Access Compliance Report Public Rights-of-Way (Curb Ramps)

Main Street: ROXBOROUGH_DR Cross Street: ROCKAWAY_DR Location: NE

ADA ID: RPRK210917121258 Ramp Type: Type 1 - Perpendicular Diagonal Initial Pass/Fail: Pass Overall Compliance: No Severity Score: 2

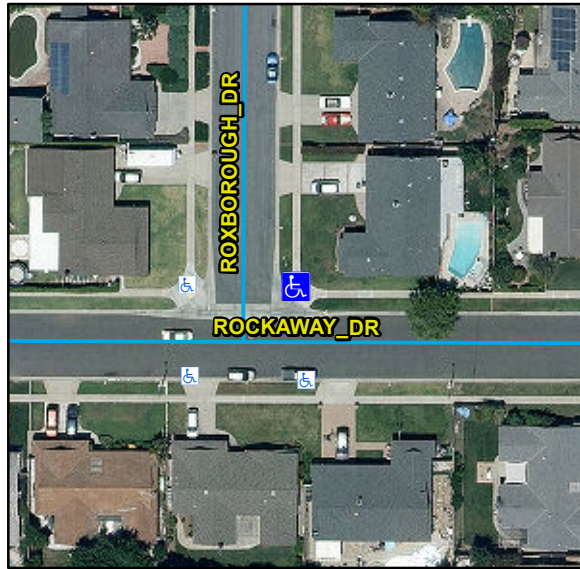
R304.2.2, R304.2.1, R304.5.3, STD 1115

Remove & Replace Curb Ramp With Two New Directional Ramps or Equivalent. Remove & Replace Gutter.
